AGENDA

ARCHITECTURAL REVIEW BOARD MEETING
CITY HALL, 385 SOUTH GOLIAD STREET, ROCKWALL, TEXAS
APRIL 29, 2025 IN THE CITY COUNCIL CONFERENCE ROOM AT 5:00 PM

PROJECT COMMENTS

PROJECT NUMBER: SP2025-014
PROJECT NAME: Site Plan for a Retail/Office Building
SITE ADDRESS/LOCATIONS: 2351 HARBOR HEIGHTS DR

Sheet Title:
SITE PLAN

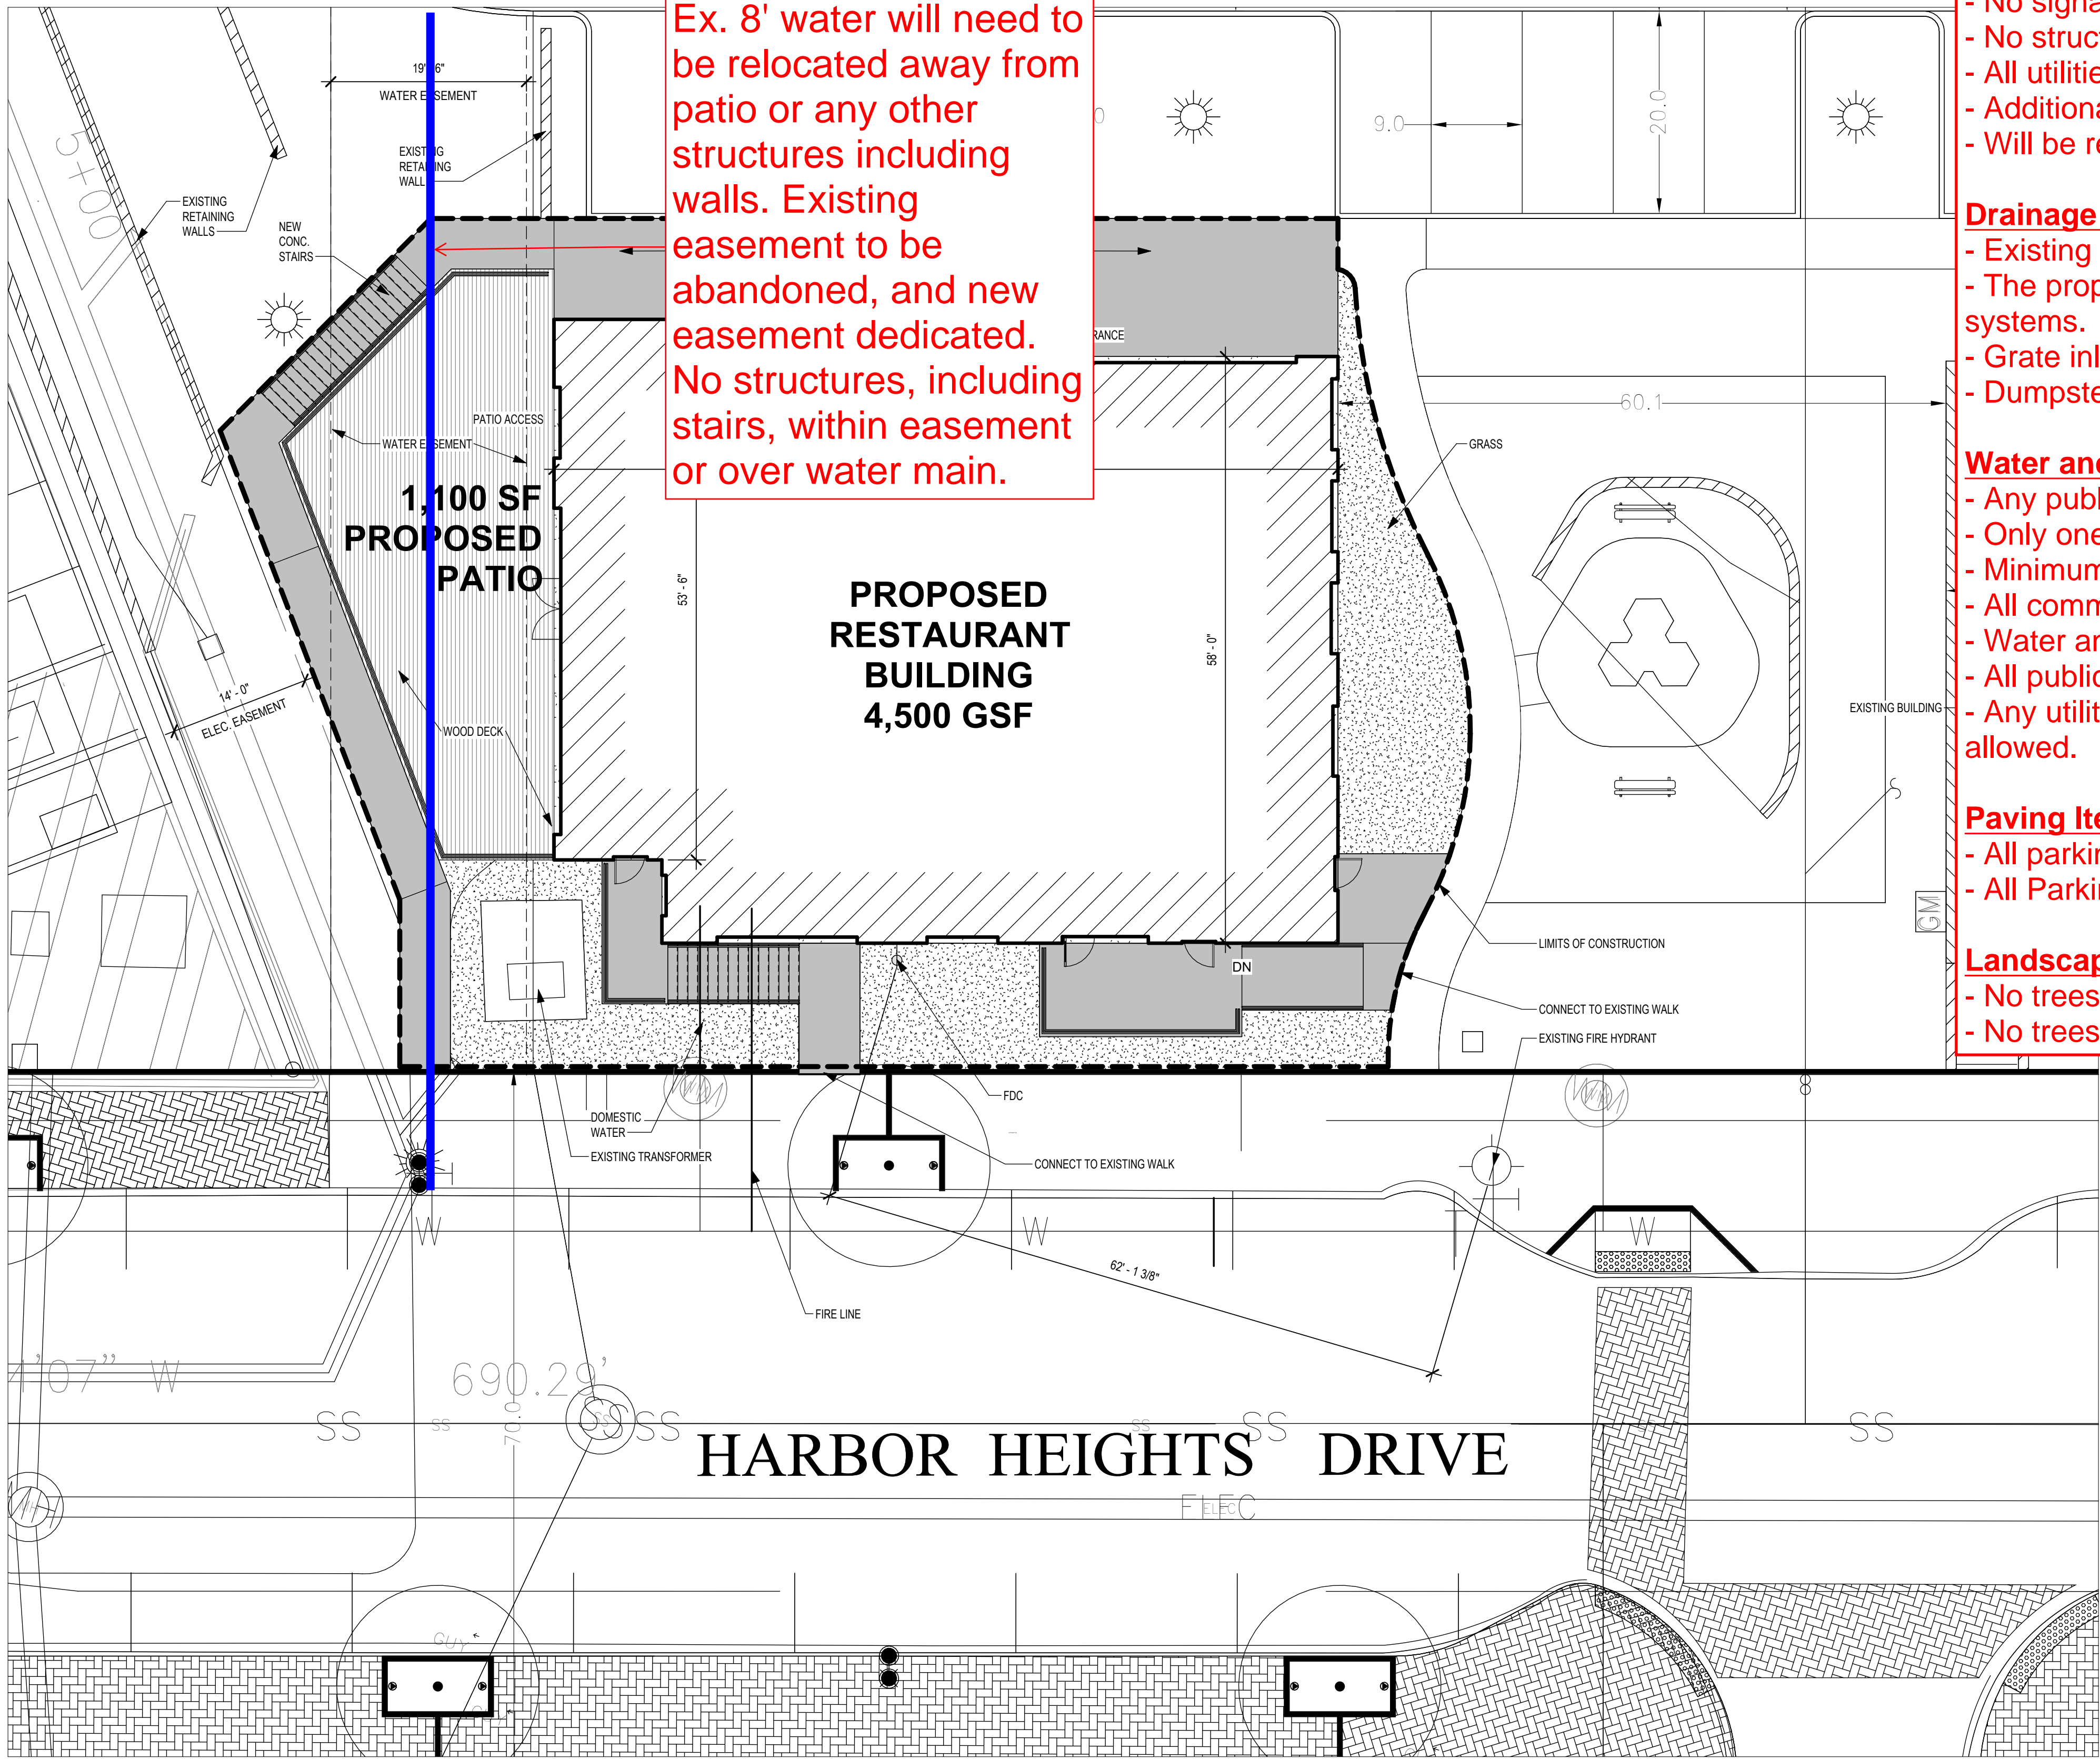
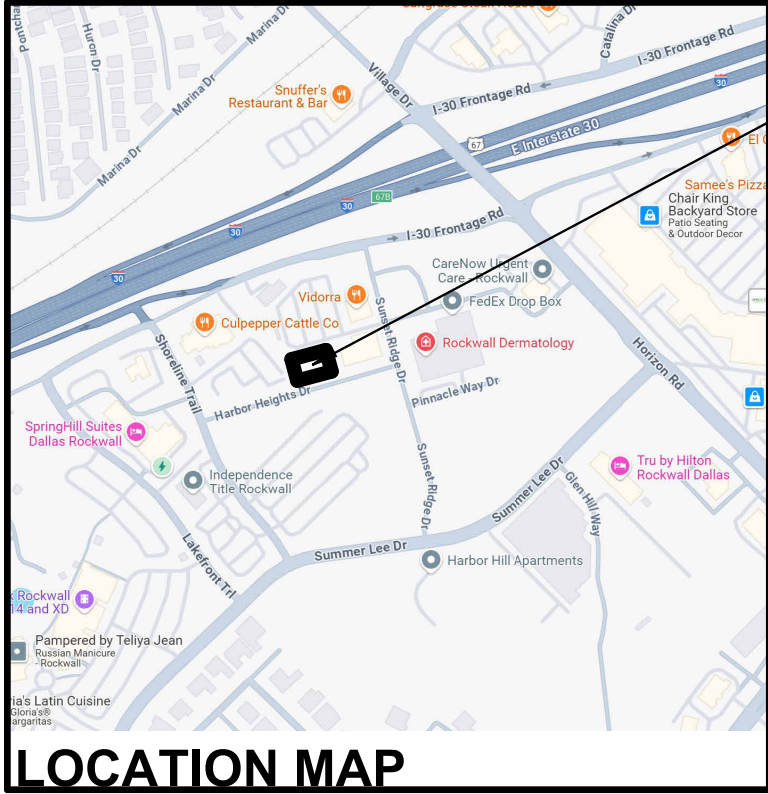
(1) Pad mounted utility equipment, and air conditioning units, shall be screened from horizontal view from any adjacent public street and from any adjacent property. Utility equipment and air conditioning units shall be screened utilizing plantings berms, or walls matching the main structure. (Subsection 01.05.C, Article 05, of the UDC) Please indicate on your site plan if there are any pad mounted utility equipment. Utility equipment will be subject to screening if found later at engineering or building permit.

(3) The maximum square footage for this building is 4,000 SF according to the PD Development Plan [Ordinance No. 19-25]. This will be a variance to the PD Development Plan.

- 1) Provide evergreen shrubs screening the existing transformer. (Subsection 01.05.C, Article 05, of the UDC)

EXTERIOR
ELEVATIONS

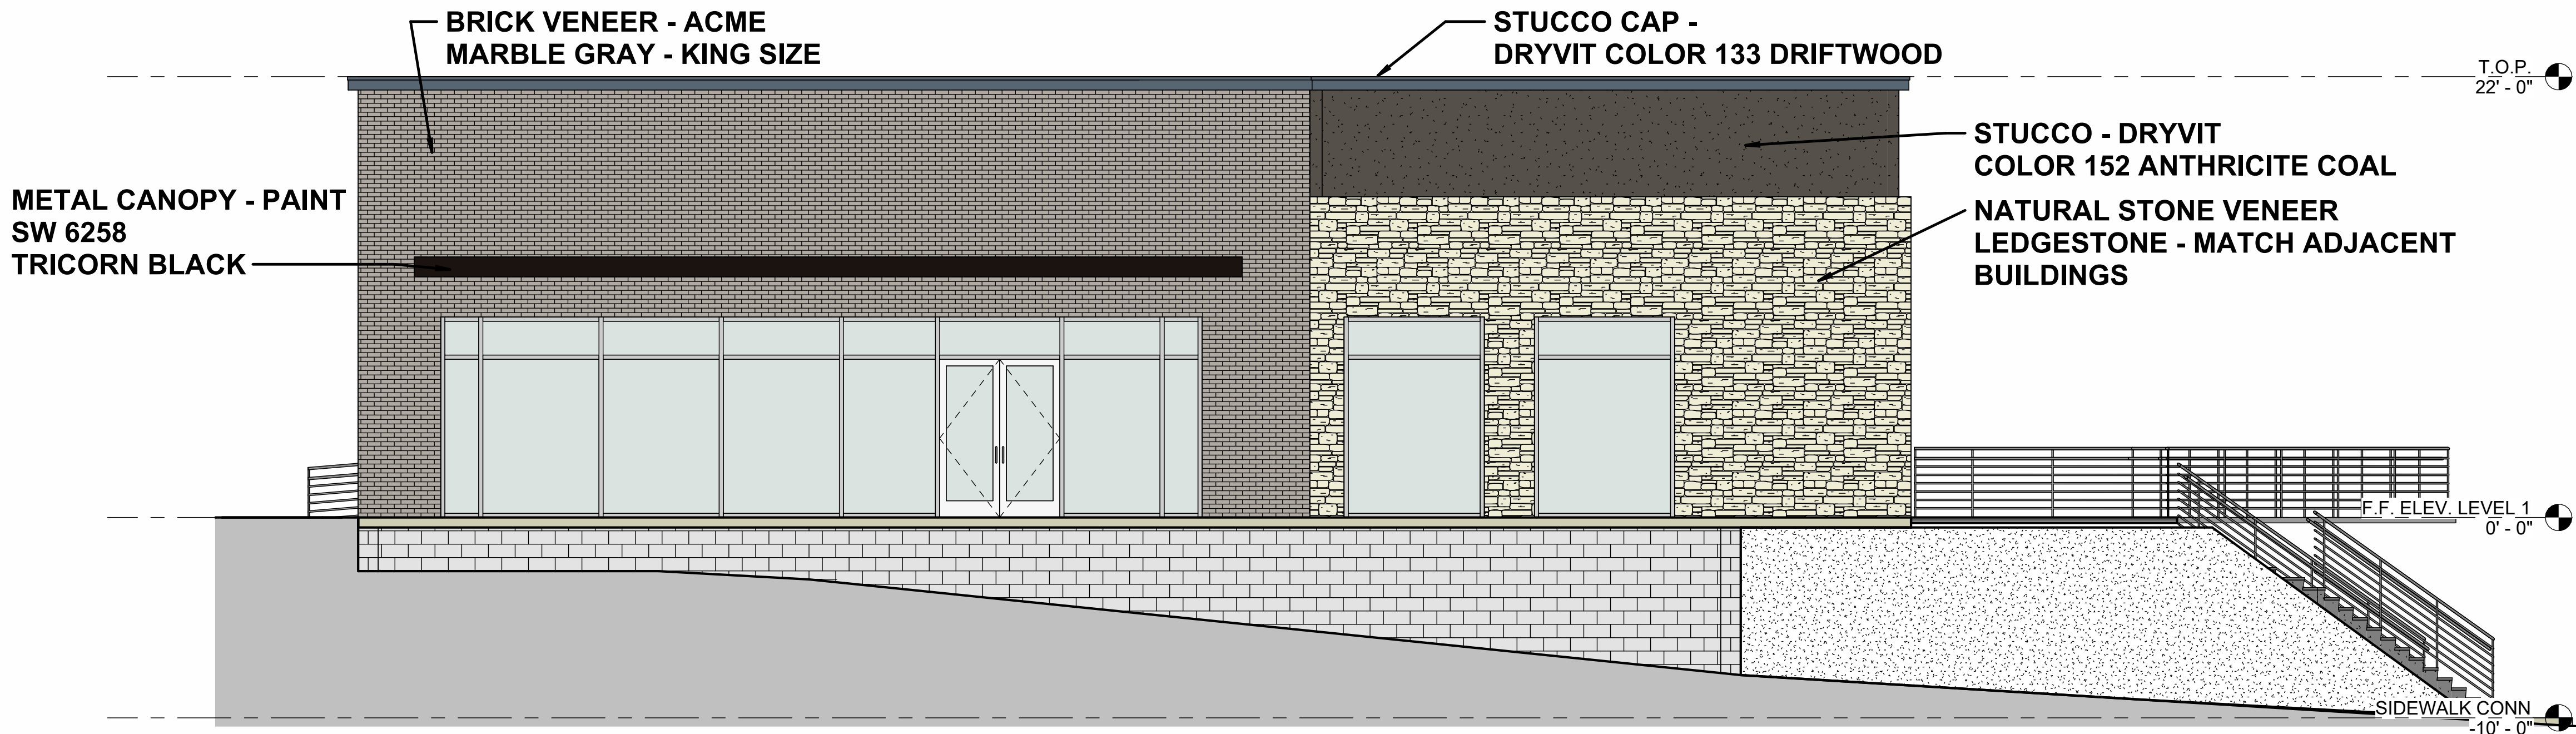
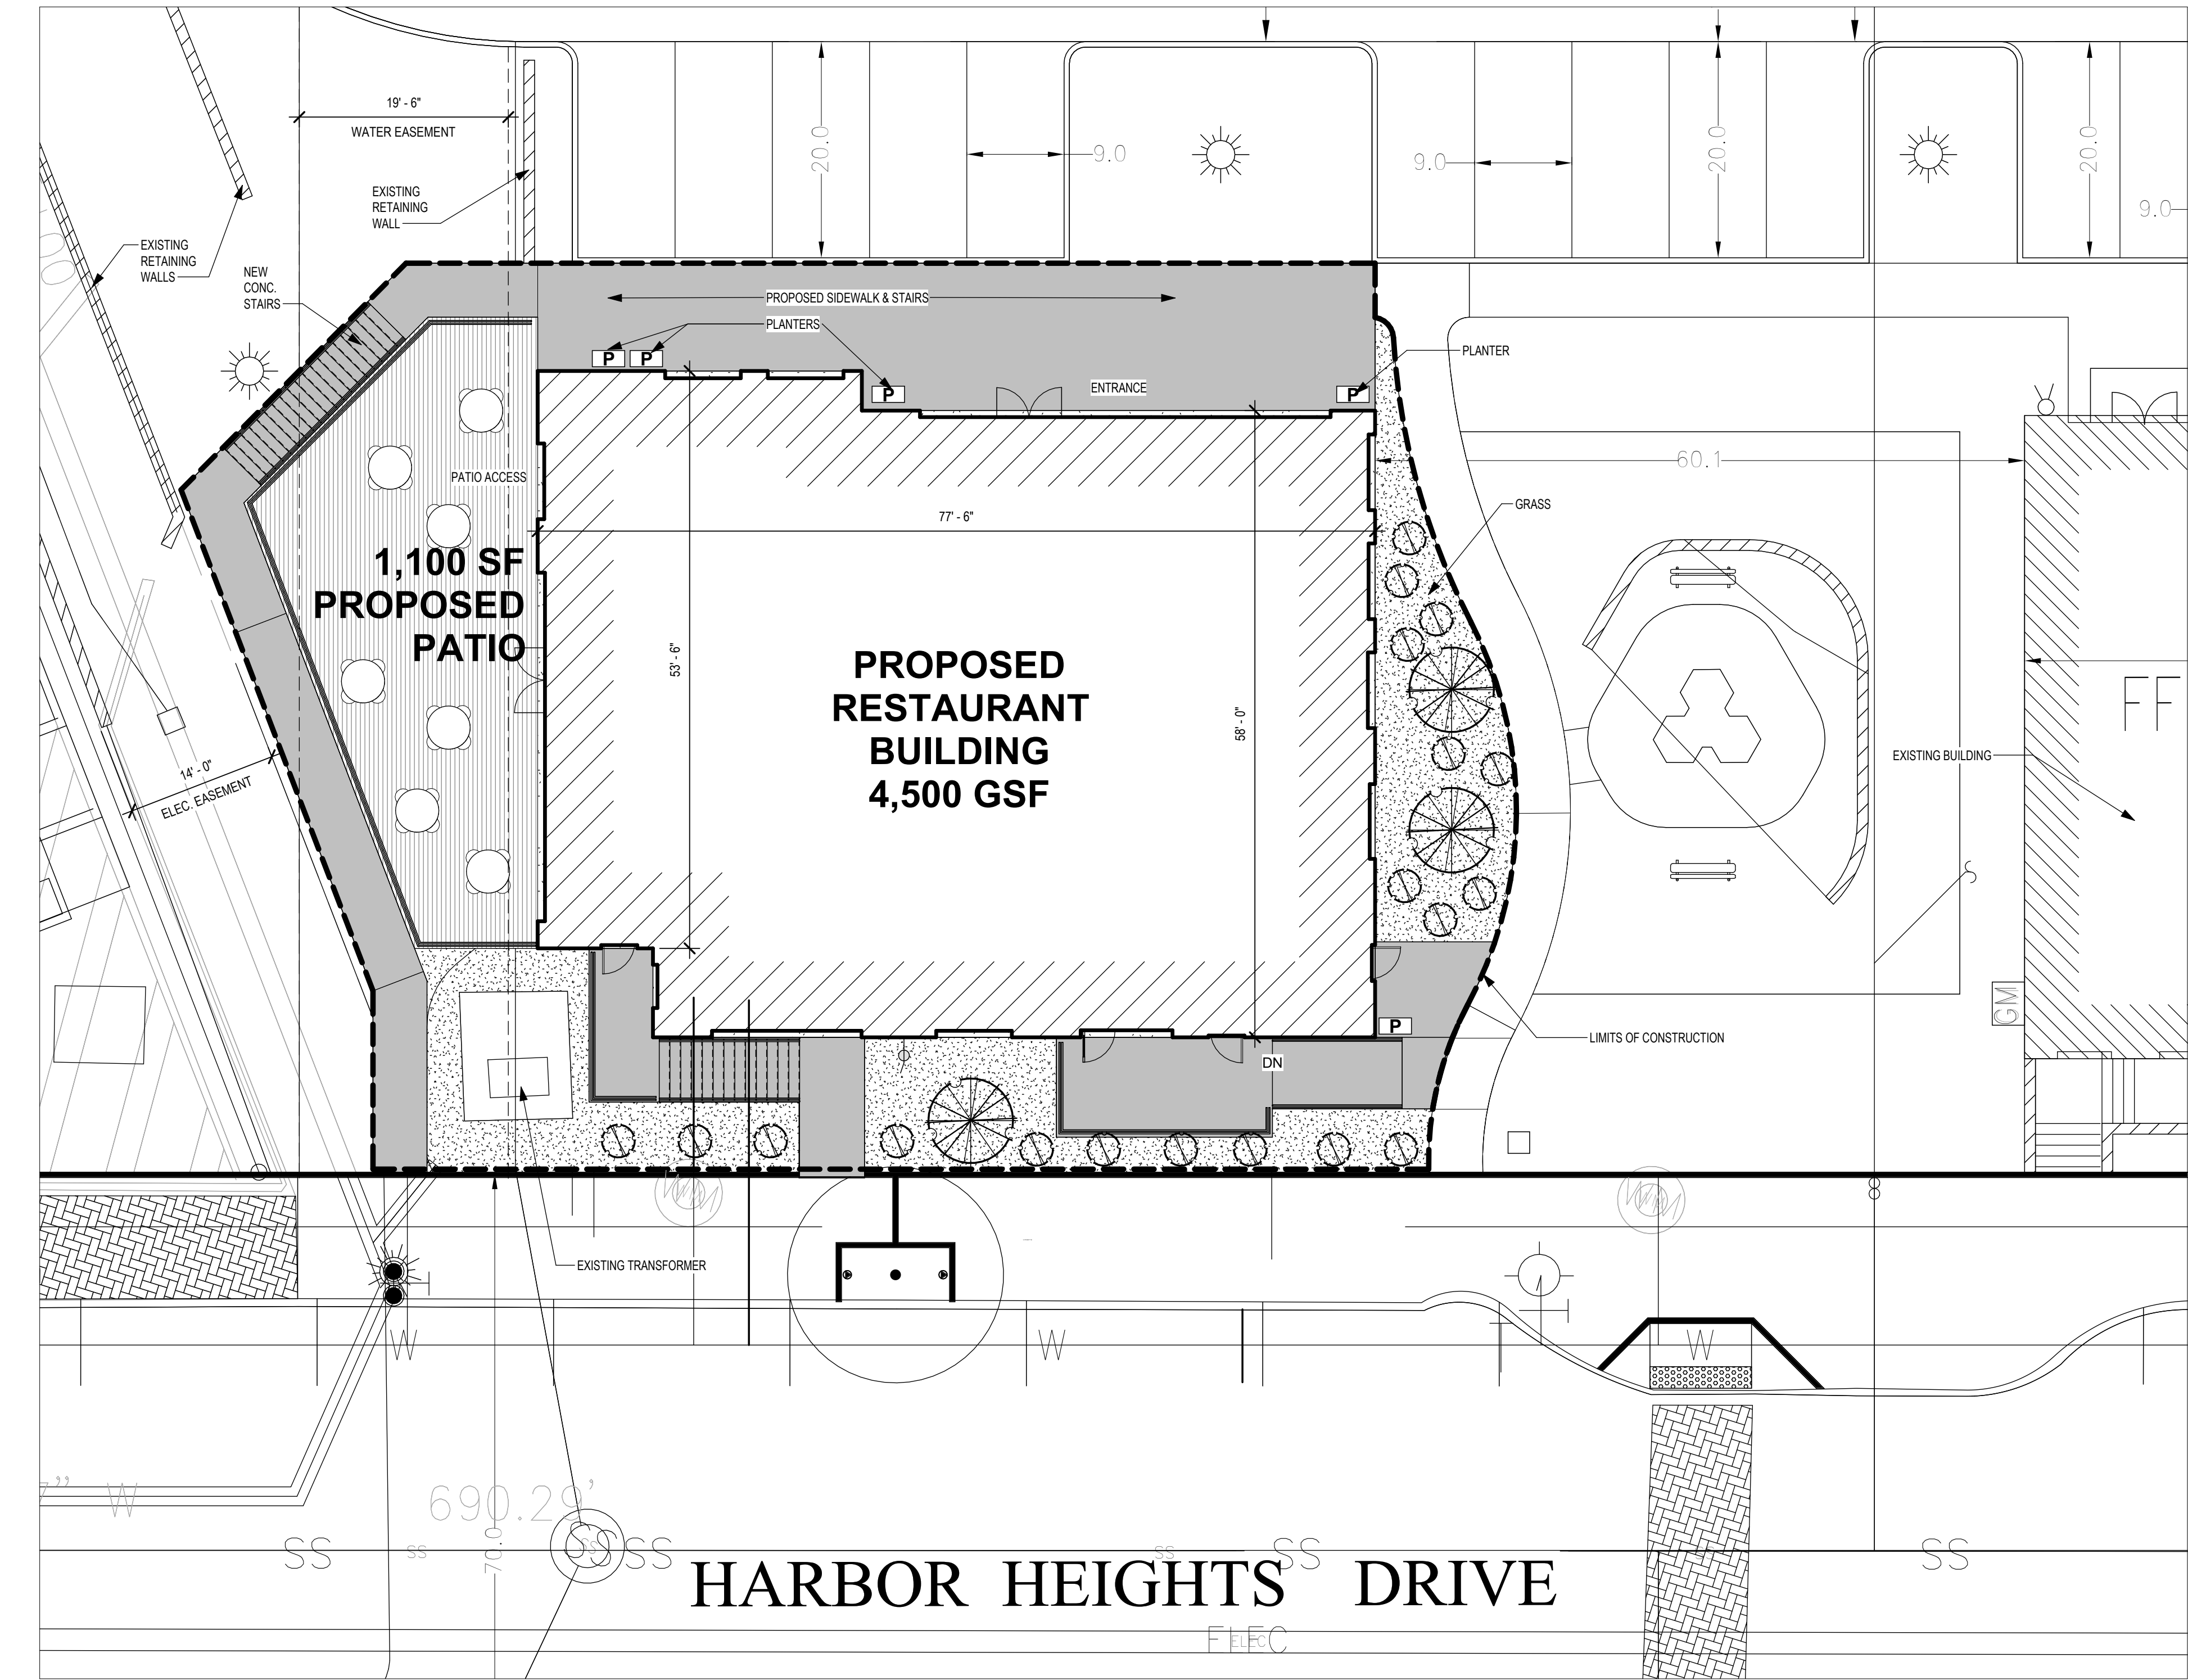
- (4) The proposed buildings' facades do not meet the Commercial Building Articulation Standards for wall projections. (Subsection 04.01.C, of Article 05, of the UDC) This will require a variance from the Planning and Zoning Commission.

- (5) All structures that have a building footprint of less than 6,000 SF shall be constructed with a pitched roof. (Subsection 06.02.C.2, of Article 05, of the UDC) This will require a variance from the Planning and Zoning Commission.

- (6) All buildings shall be architecturally finished on all four (4) sides utilizing the same materials, detailing, articulation and features. (Subsection 06.02.5, of Article 05, of the UDC and Planned Development District 32 [Ordinance 19-25]). This will require a variance from the Planning and Zoning Commission.

- (1) Four-sided Architecture. According to Article 05, General Overlay District Development Standards, of the Unified Development Code (UDC), "all buildings shall be architecturally finished on all four (4) sides utilizing the same materials, detailing, articulation and features. In addition, a minimum of one (1) row of trees (i.e. four [4] or more accent or canopy trees) shall be planted along perimeter of the subject property to the rear of the building." In this case, the proposed building does not meet the articulation standards for all four (4) facades.
